**Report: Commissioning**

## Shake Shack (Chesterfield) - Commissioning

***Shake Shack – Chesterfield, MO (FIV) In-Wall Inspection Summary (March 16<sup>th</sup>, 2022)***

damaged\_DOAS\_outdoor\_coil.jpg

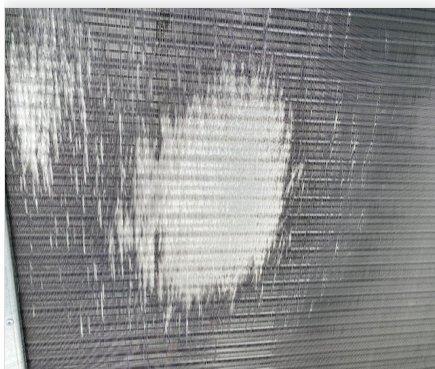
**Issue Name :** MC: Kitchen DOAS - Condenser Coil Damage, missing hail guard  
**Description :** Unit's condenser coil has damage to fins on face lower left end of coil. Unit was not provided with hail guard  
**Created By :** National TAB **Assigned To :** Crystal Heating & Cooling - Billy Gray  
**Status :** Open  
**Originated Date :** 03/06/2022 - Dan Hertenstein - National TAB

- **03/10/2022** **Crystal Heating & Cooling - Billy Gray**
  - Kitchen DOAS is owner supplied and had coil damage on delivery. No hail guards were shipped with unit, also nothing in the notes calling for hail guard.

planned\_circuit\_layout\_addendum\_E.PNG

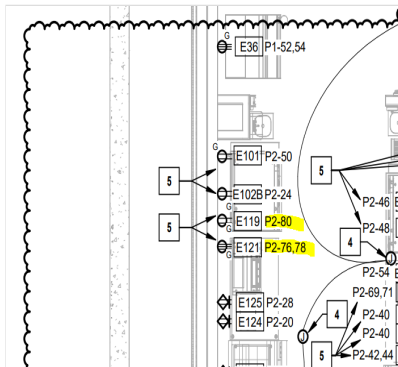
In-Wall Junction boxes are installed per electrical and food equipment plan to serve appliances, office equipment, Indoor signs and other necessary functions (no missing outlets)	All in-Wall outlets (excluding dining) validated and approved. See attached photo for circuit label correction for planned labeled circuits P2-80 (Item E119) and P2-76,78 (Item E121). GC spoke with electrician and indicated labeling of CB's will change but power and phase loading will remain as designed
--	--

Most boxes labeled, a few not marked but identified by location
